**PLAN COMMISSION PC #21-009**  
**Ridgeline Distribution Center**  
**1100, 1400 W. Dundee Rd. and 1500-1530 W. Dundee Rd**  
**Round 3**

# Planning & Community Development Dept. Review

Project: Ridgeline/Rohrman Redevelopment

Case Number: PC 21-009

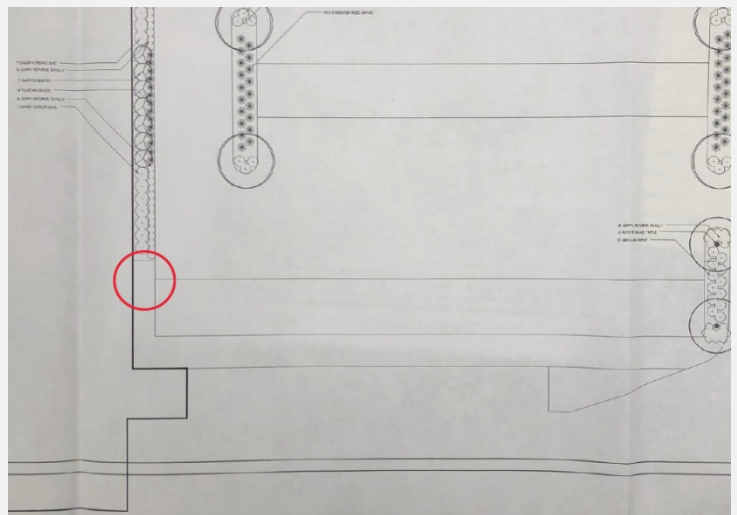
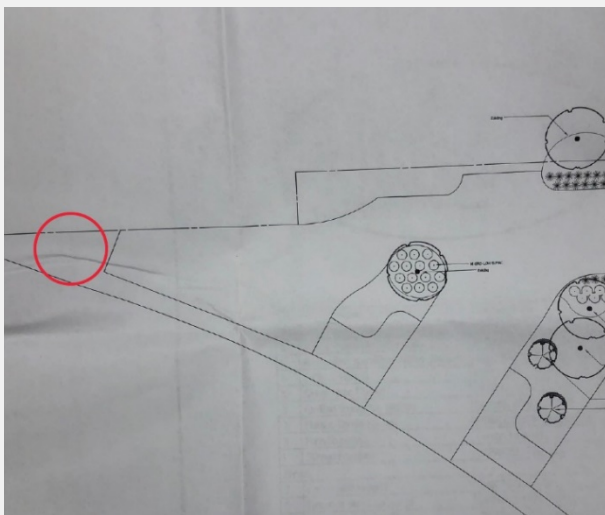
67) The response to comment 40 is not acceptable. Shade trees are required at the ends of all parking rows. Shade trees are missing in the following locations. Either incorporate the required shade trees or request a variation and provide the required written justification, which includes **a response to each of the 4 approval criteria.**
